H. B. ROBINSON STEAM ELECTRIC PLANT, UNIT NO. 2
DOCKET NO. 50-261/LICENSE NO. DPR-23

RESPONSE TO NRC REQUEST FOR
ADDITIONAL INFORMATION REGARDING PROPOSED
TECHNICAL SPECIFICATIONS CHANGE TO SECTION 3.5.2

RESPONSE TO NRC REQUEST FOR ADDITIONAL INFORMATION REGARDING PROPOSED TECHNICAL SPECIFICATIONS CHANGE TO SECTION 3.5.2

Figure 1: Planned Strainer Configuration

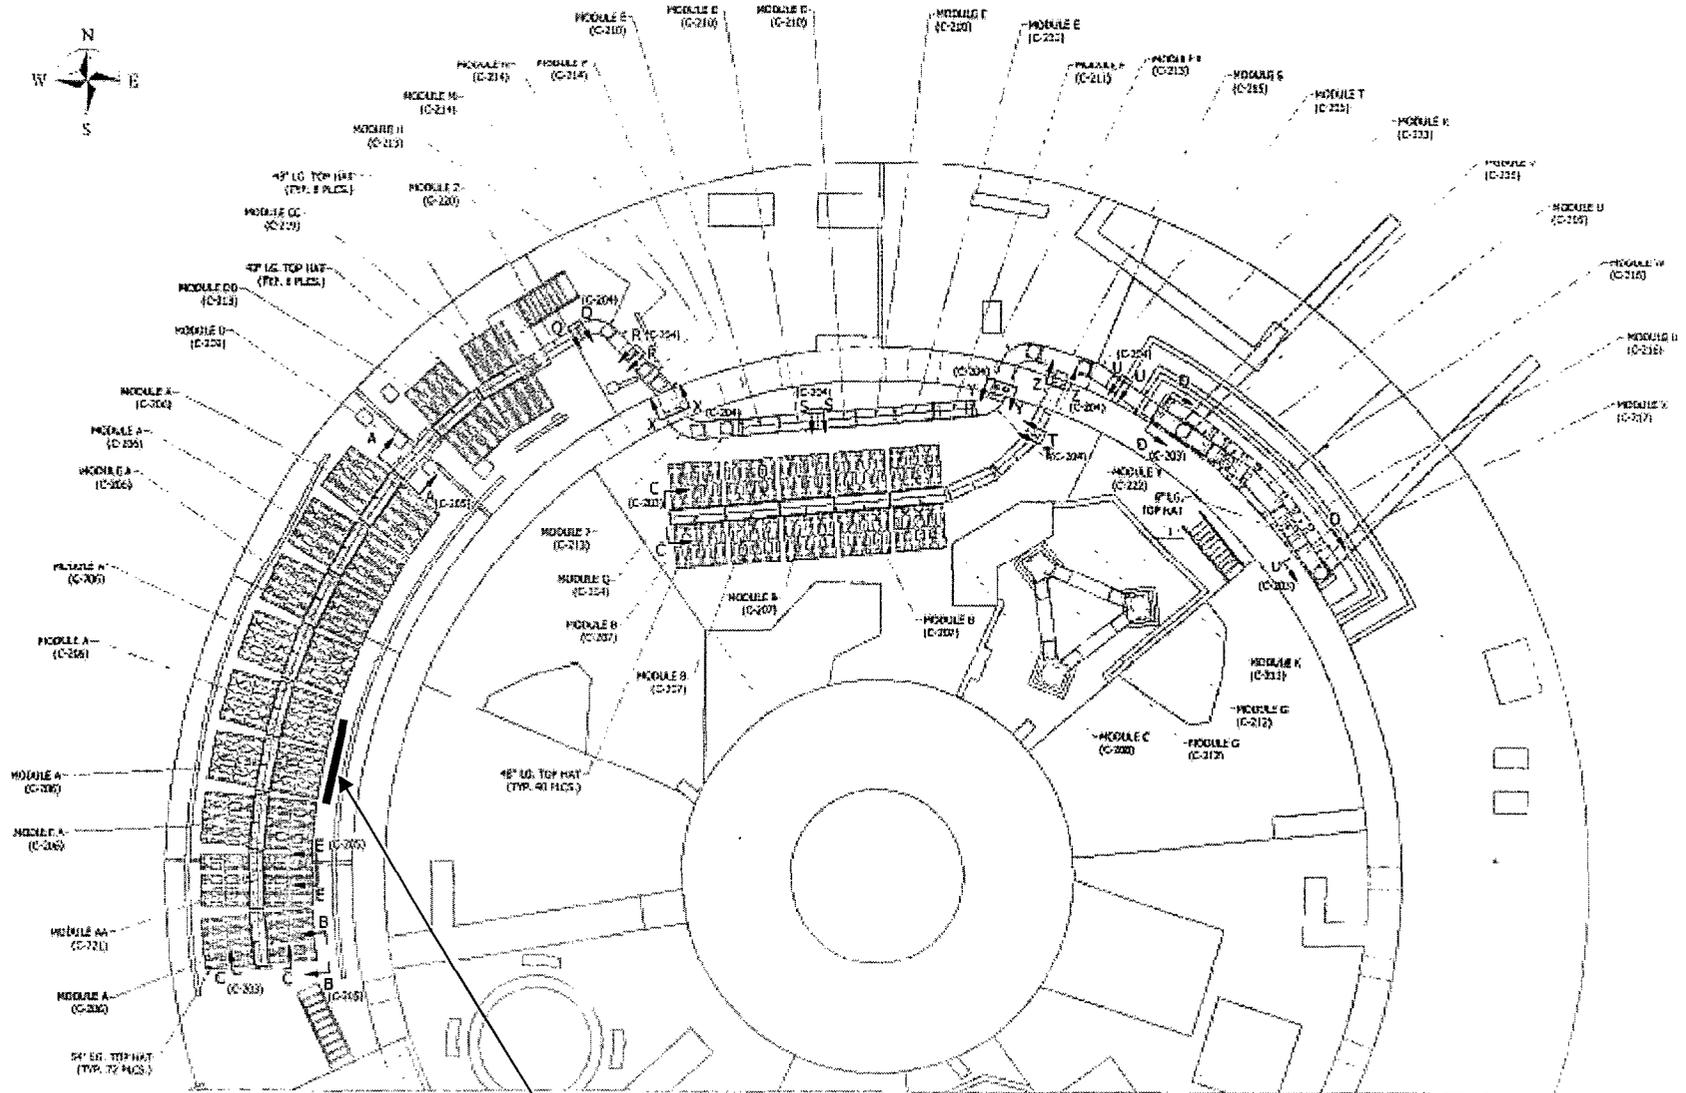
This request is for additional information (RAI) and is a follow-up to a previous NRC RAI transmitted on September 11, 2006. Your response contained a discussion of surveillance requirement of sump suction inlet & a description of the strainer assembly and included Figure 1 (Planned Strainer Configuration), and Figure 2 (Current Sump configuration).

A review of these figures indicates that one string of modules of the new strainer assembly (Figure 1), as well as portions of the new suction piping for both strings of modules are located inside the bioshield wall. The old sump screen (Figure 2) was completely outside the protective shield wall.

Please provide a summary of evaluations performed to confirm the structural adequacy of the new strainer assembly (including portions of the new suction piping at the new location) from the consideration of any potential jet impingement, missile impact, and pipe whip.

EC 63481 states that the strainer assembly is adequately protected from the hazardous effects of missiles. This conclusion is based on the evaluation of the locations of the strainer sections. The strainer sections outside the shield wall (also referred to as the crane wall) are protected by the crane wall and outer containment wall. Figure 1 from the November 20, 2006 letter is provided with this letter to show the location of these strainer sections.

EC 63481 further states that the majority of the strainer sections located inside the crane wall are under the refueling canal and that the remaining strainer sections located inside the crane wall are not in the direct line of sight of potential missile hazards inside the surrounding reactor coolant system (RCS) pump bays.

EC 63481 describes the evaluation of the potential pipe whip and jet impingement sources. This evaluation concluded that it is necessary to protect the strainer from damage that could occur due to a high energy line break in the normal letdown line, upstream of the letdown isolation valves (LCV-460A and LCV-460B). Therefore, an additional engineering change (EC 61244) was initiated to design and construct a jet impingement shield to protect the strainer from a high energy jet that could emanate from the normal letdown line upstream of the letdown isolation valves. The approximate location of the proposed jet impingement shield is provided on Figure 1.

Approximate location of proposed jet impingement shield
